SHEET 22
PROPOSED UTILITY WASTE LANDFILL
CROSS SECTIONS A-A' AND B-B'

THE ENGINEER WHOSE SIGNATURE AND PERSONAL SEAL APPEAR HEREON ASSUMES RESPONSIBILITY ONLY FOR WHAT APPEARS ON THIS PAGE AND DISCLAIMS PURSUANT TO SECTION 327.411 (RSMO) ANY RESPONSIBILITY FOR ALL OTHER PLANS, SPECIFICATIONS, ESTIMATES, REPORTS OR OTHER DOCUMENTS OR INSTRUMENTS NOT SEALED BY THE UNDERSIGNED ENGINEER RELATING TO OR INTENDED TO BE USED FOR ANY PART OR PARTS OF THE PROJECT TO WHICH THIS PAGE REFERS.		REITZ & JENS, INC. CONSULTING ENGINEERS 1005 CORPORATE SQUARE DRIVE ST. LOUIS, MISSOURI 63132 314.993.4132 (voice) 314.993.4177 (fax)		GREDELL Engineering Resources, Inc. ENVIRONMENTAL ENGINEERING AIR WATER 1305 East High Street Jeffersonville, IN 47130 317.434.0101	
DRAWN M.J.A. (G.E.R.) CHD. R.L.R. (G.E.R.) SUPV. T.R.G. (G.E.R.) APPD. T.R.G. (G.E.R.)		LOCATION 001009		CLASS 02010	
PREPARED FOR Ameran		SHEET 23 PROPOSED UTILITY WASTE LANDFILL CROSS SECTIONS C-C' AND D-D'		JANUARY 2013

**Ameren Missouri
Labadie Energy Center
Construction Permit Application for a
Proposed Utility Waste Landfill
Franklin County, Missouri**

January 2013, REVISED August 2013

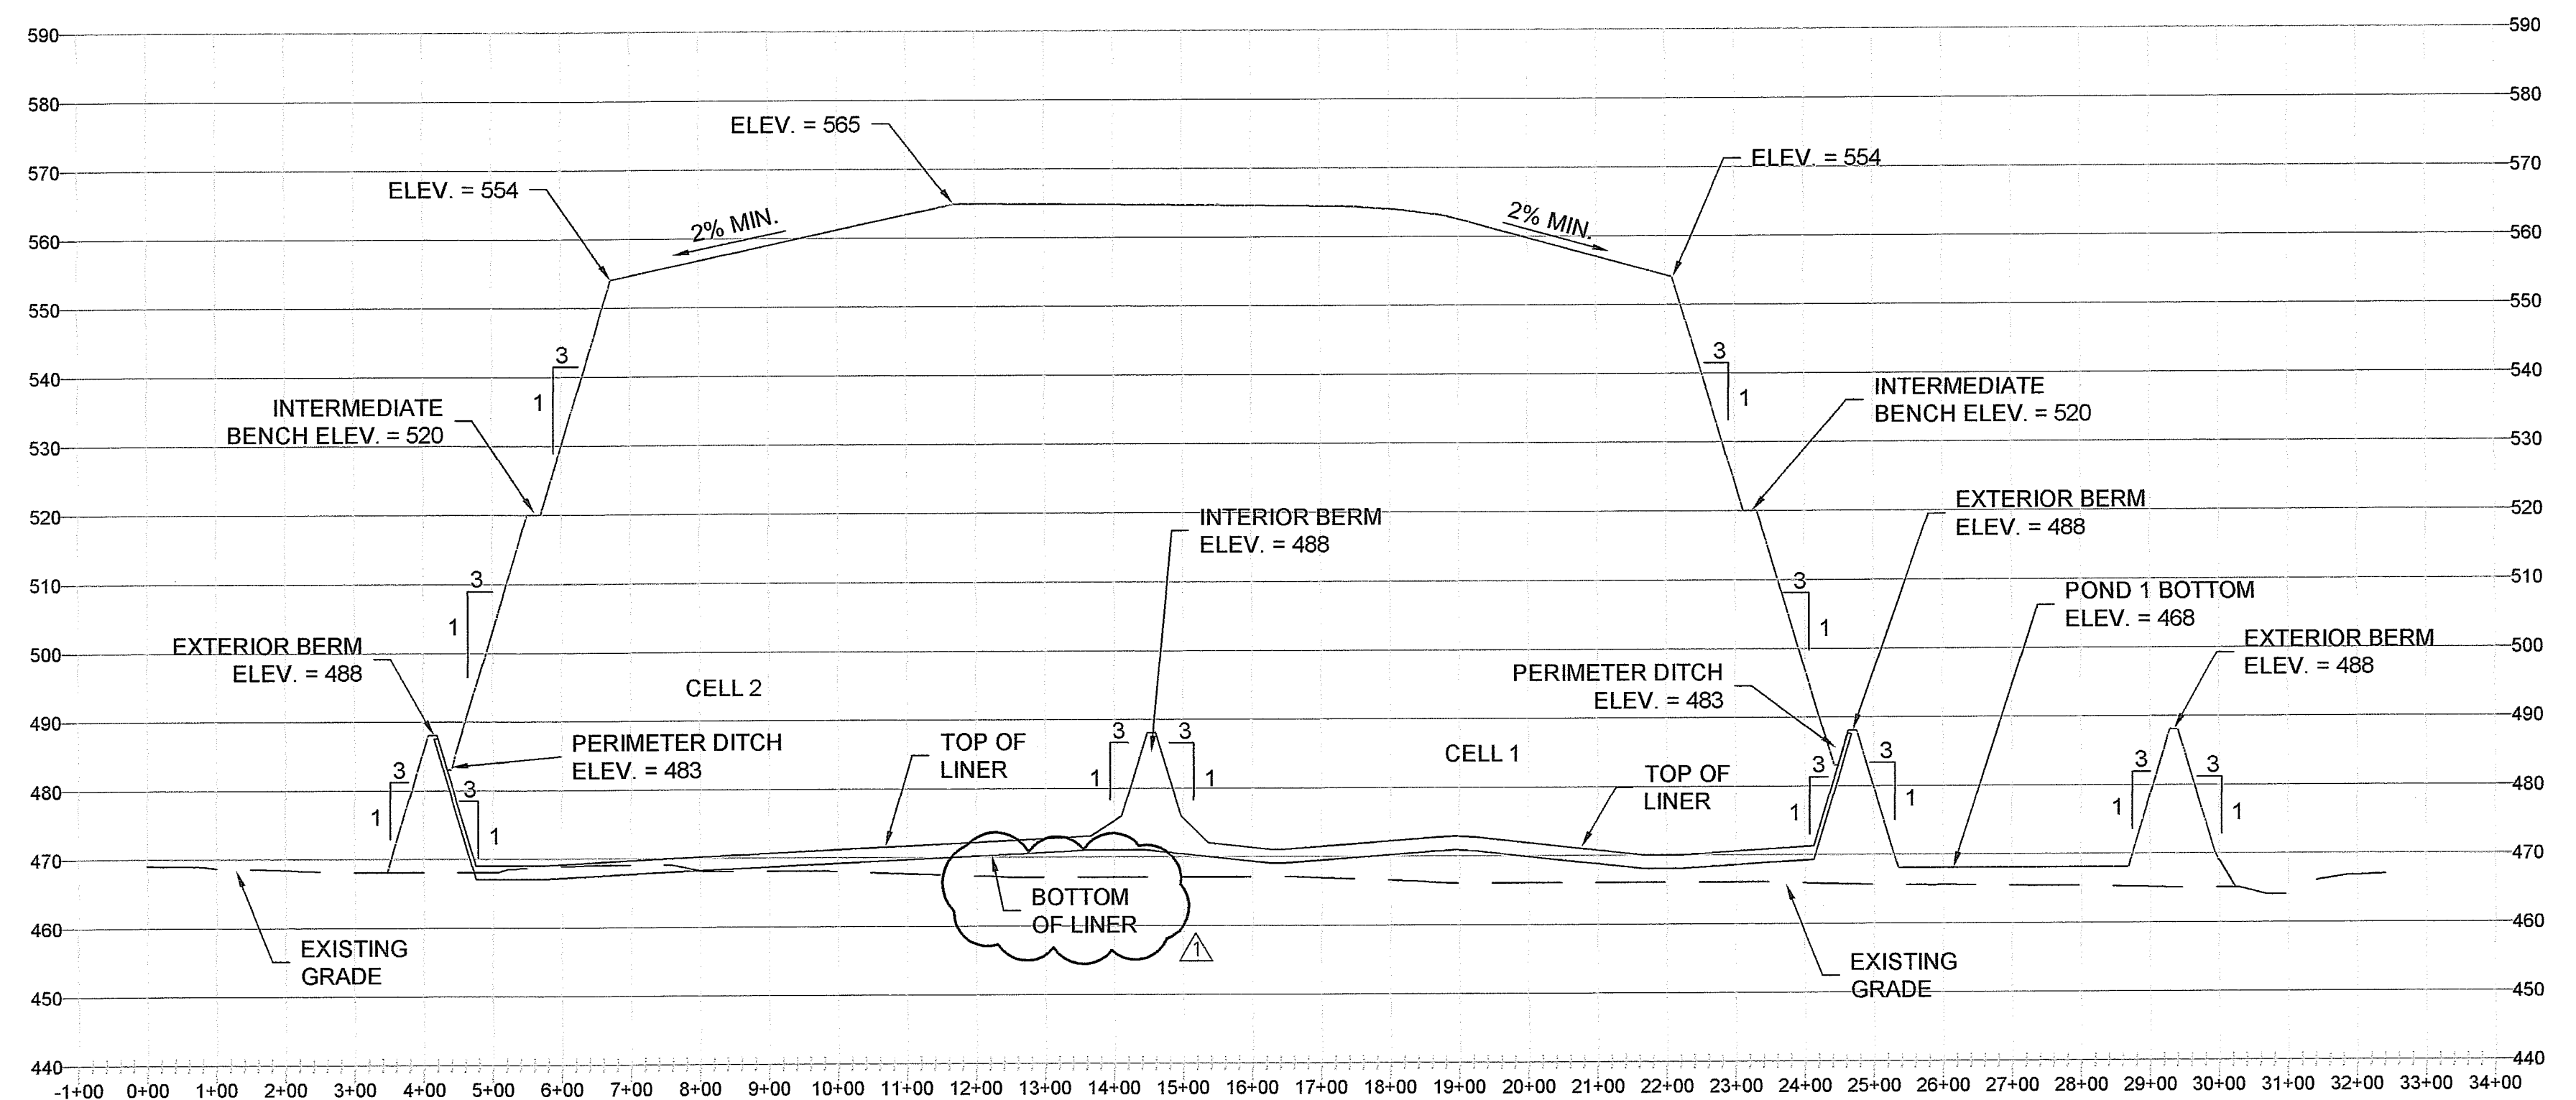
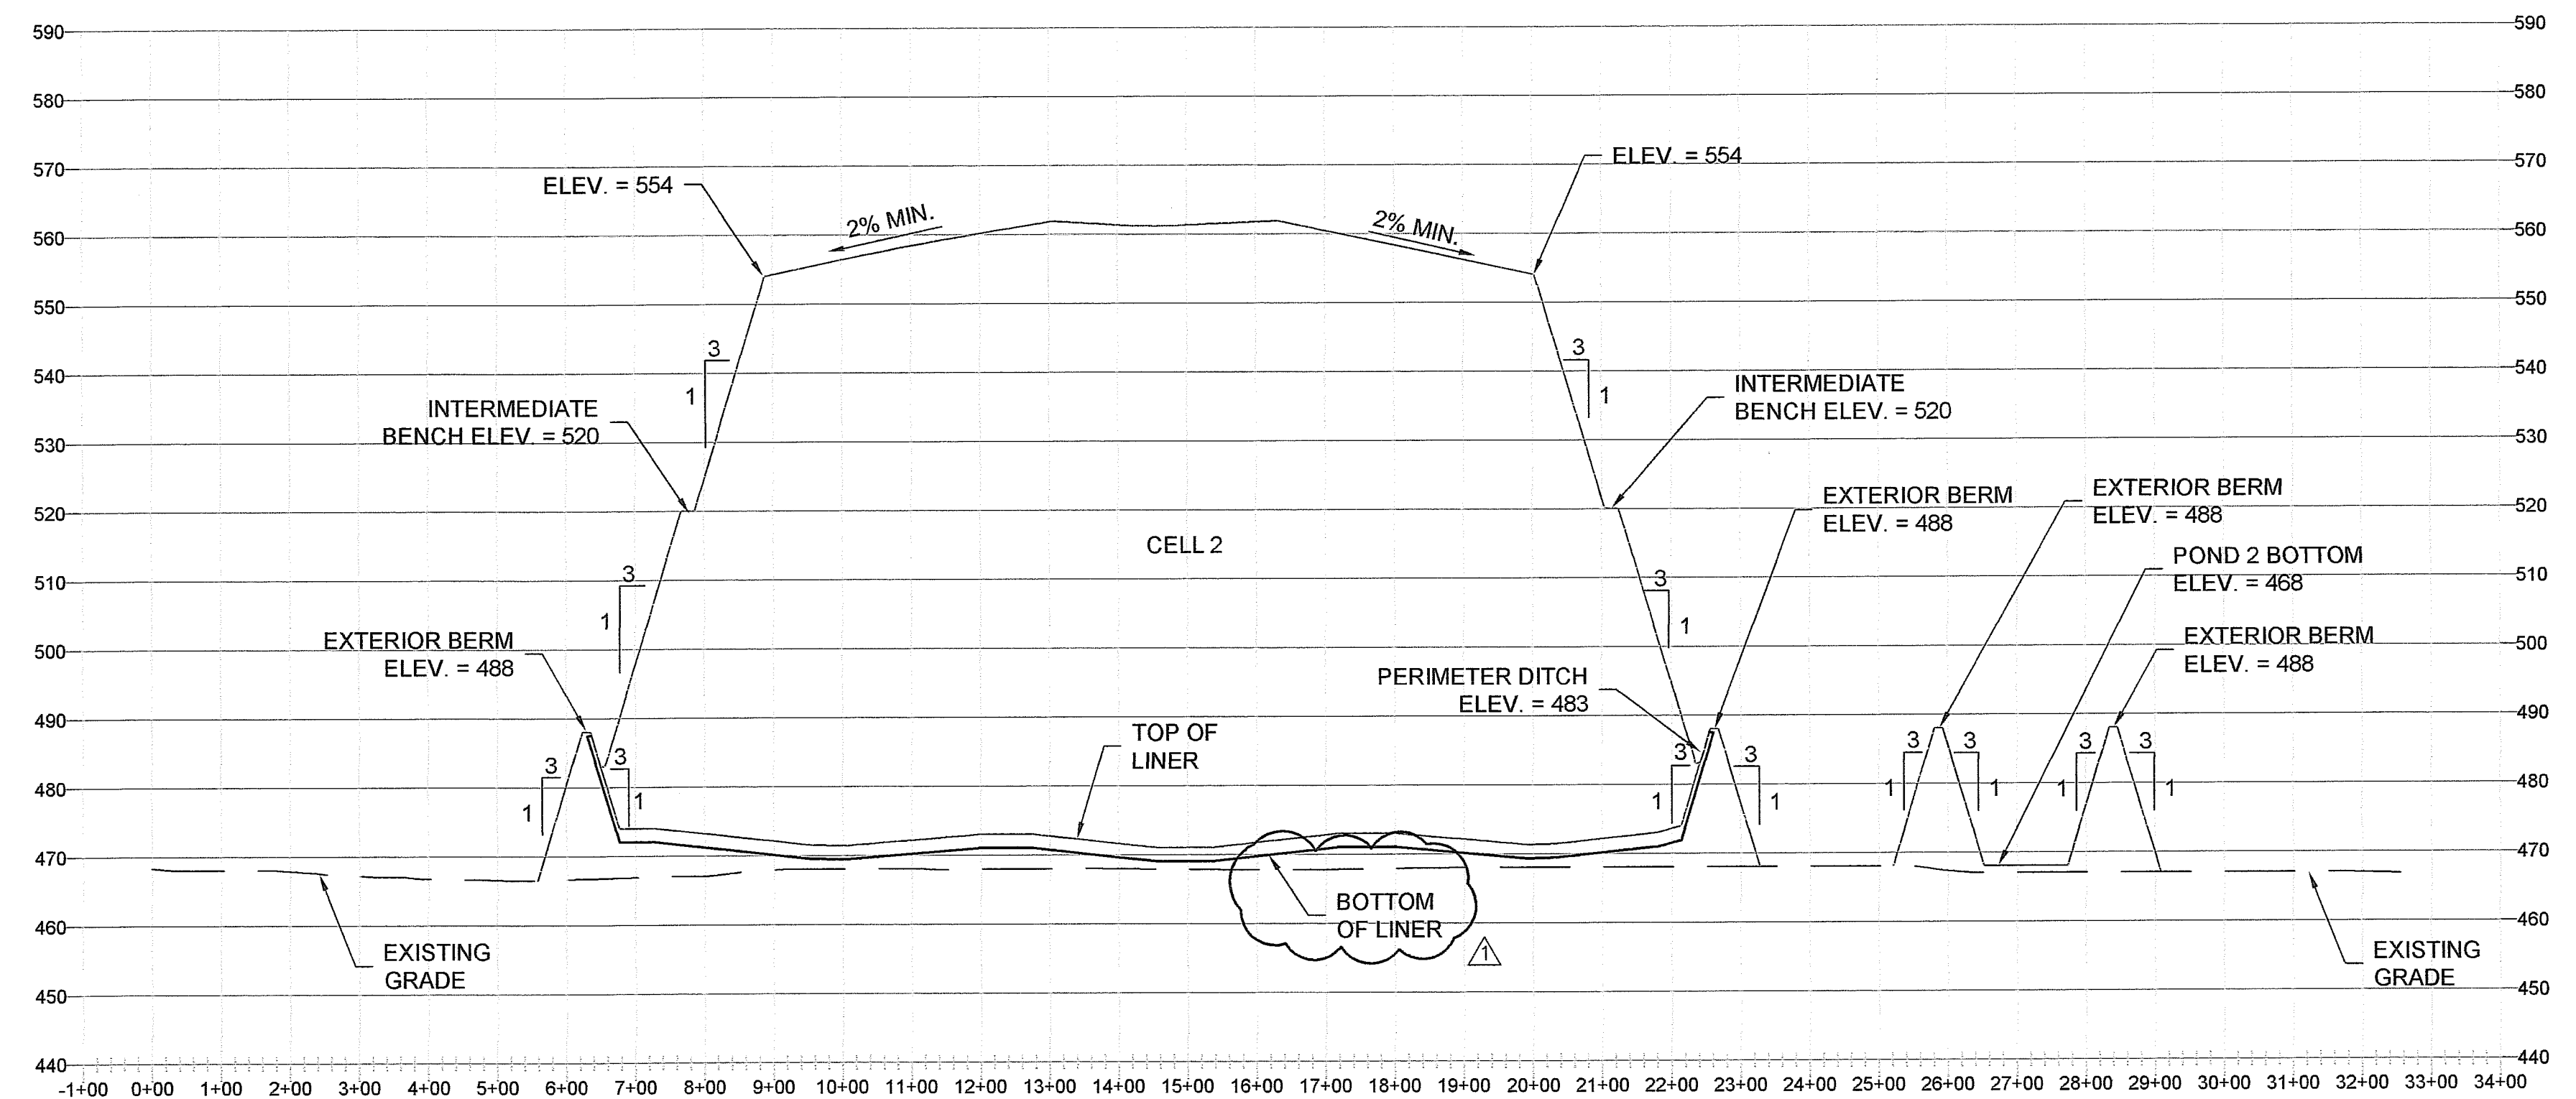
PRINT	DIST.	REVISIONS
1	1	W.O. SYM
06/02/13	13	SHOW BOTTOM OF LINER

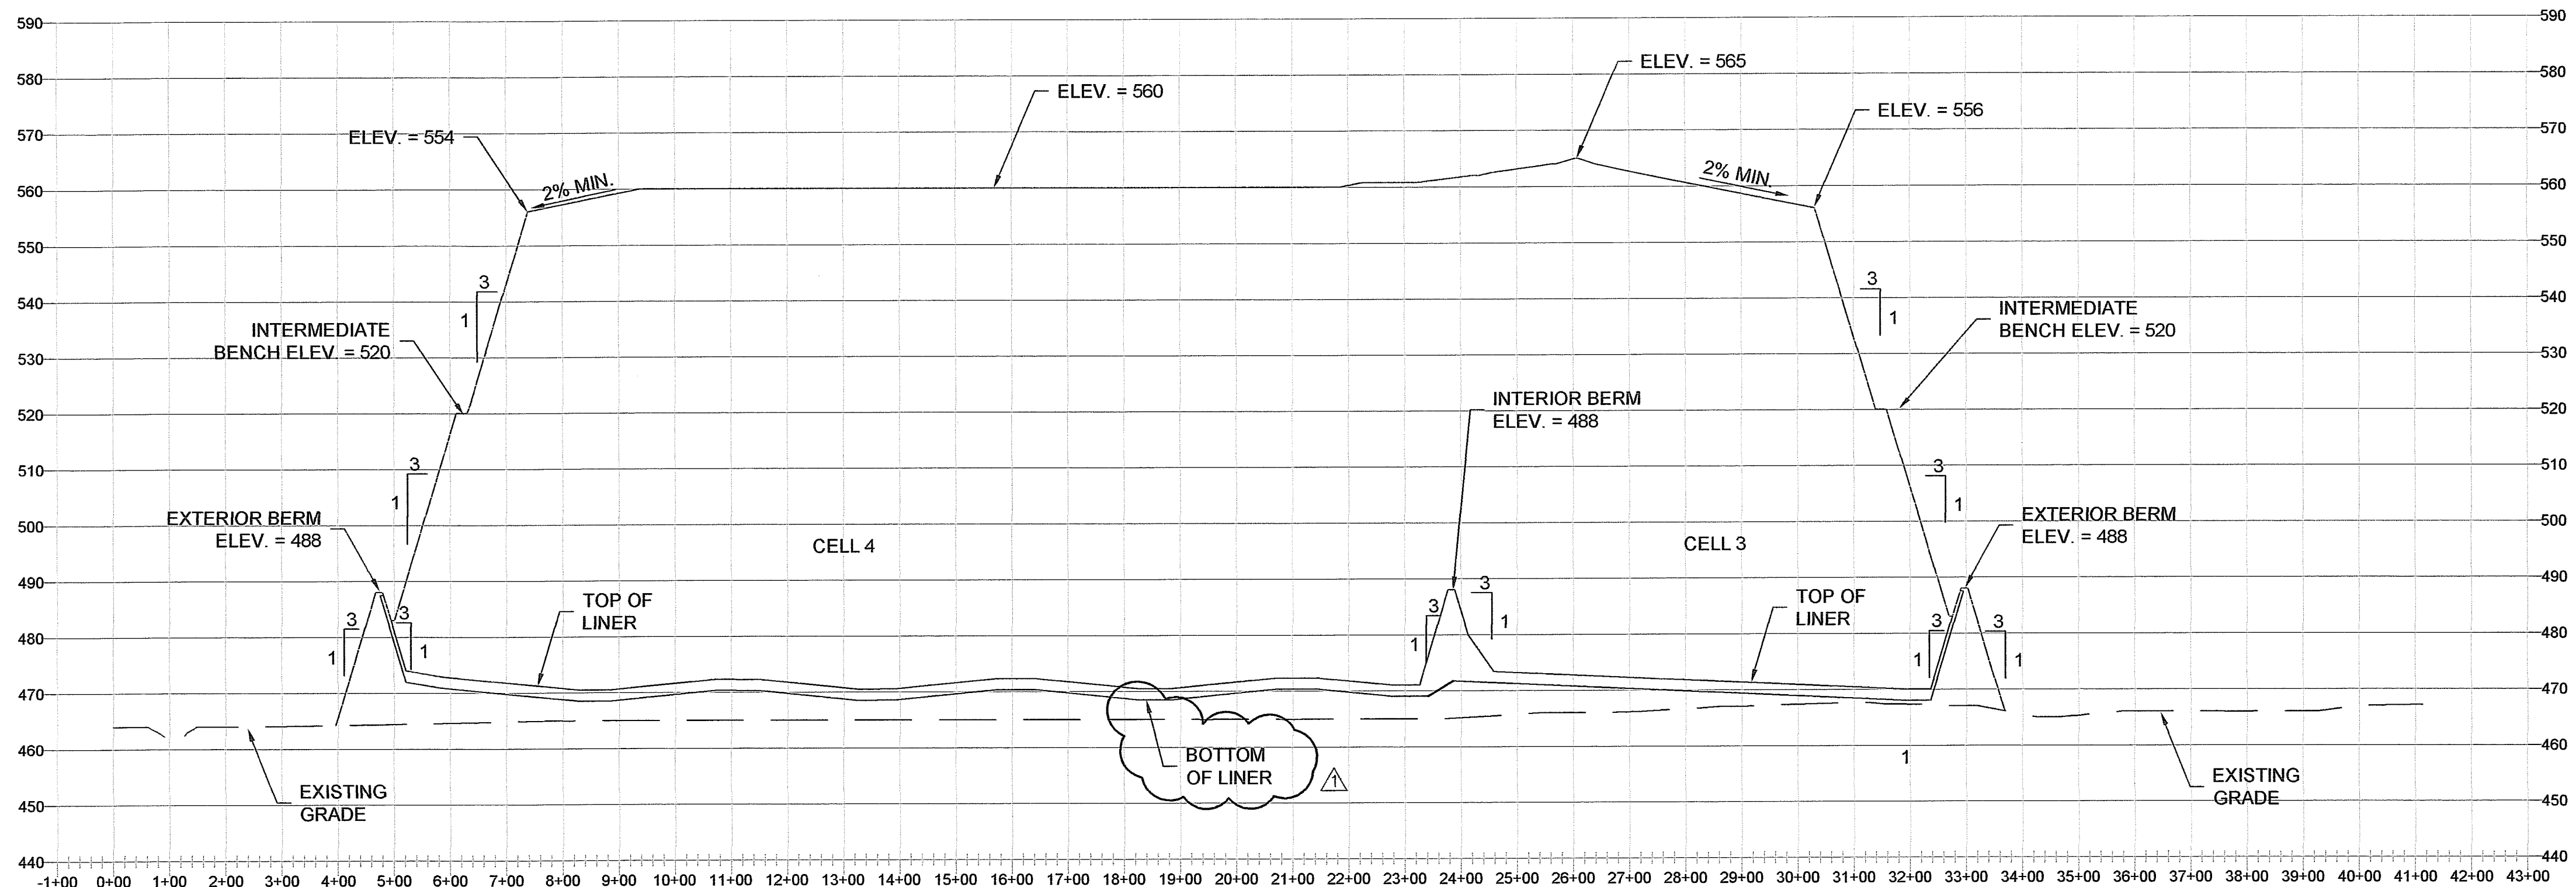
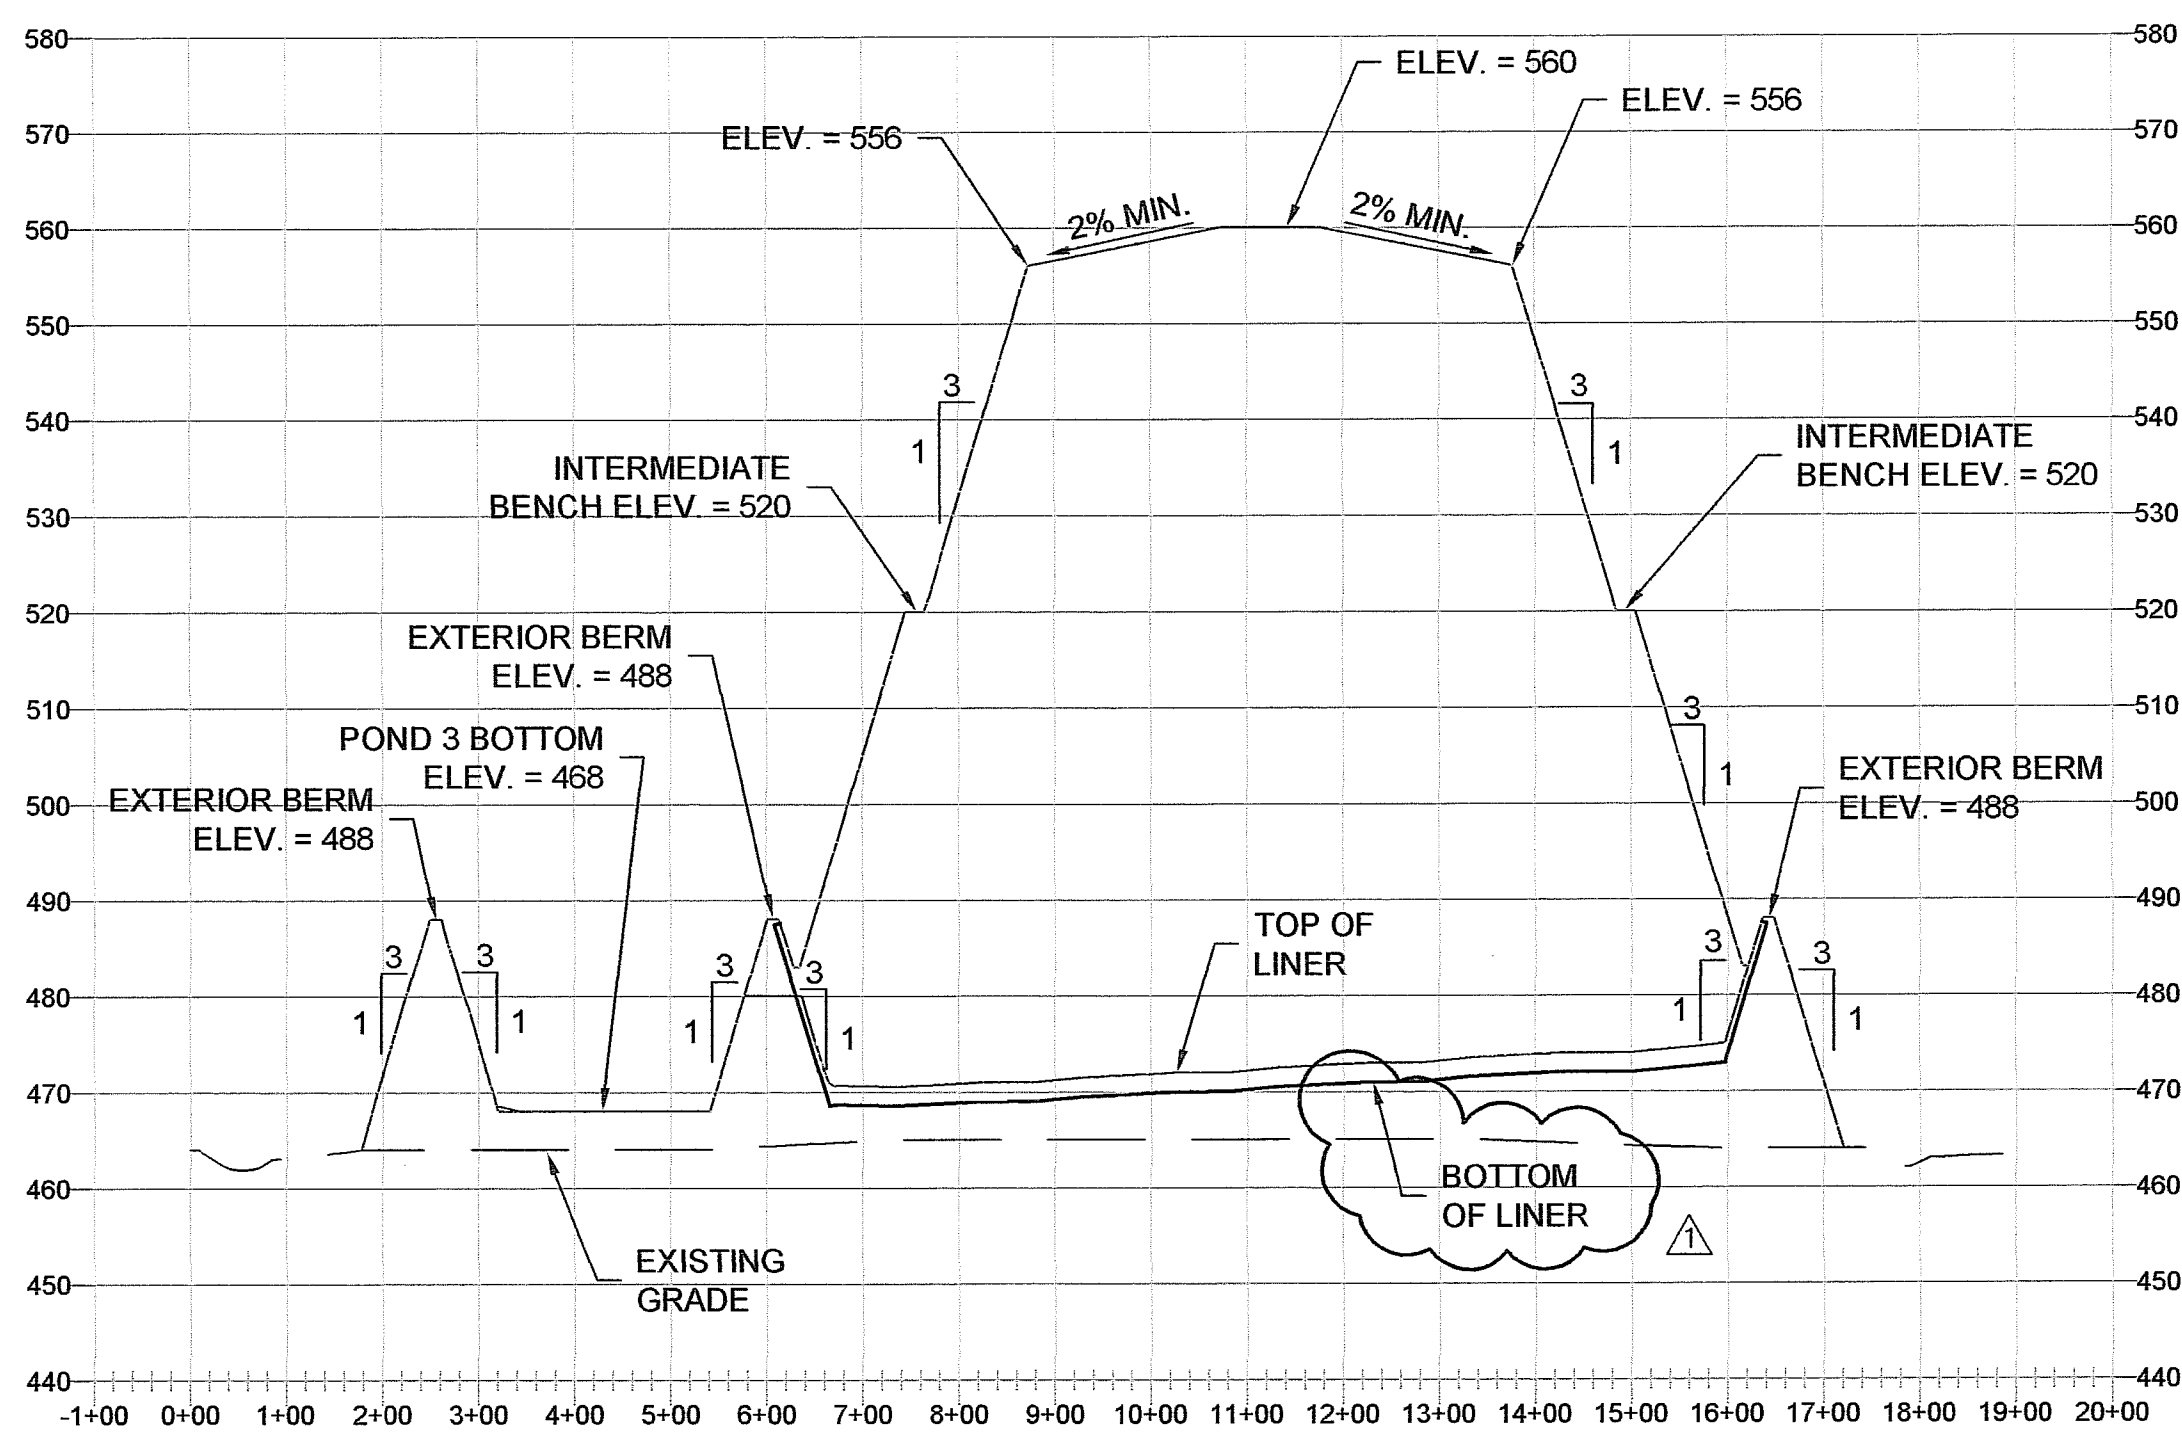
PRINT DIST		
REVISIONS		
REV.	W.O.	SYM
1		
08/02/13: SHOW BOTTOM OF LINER.
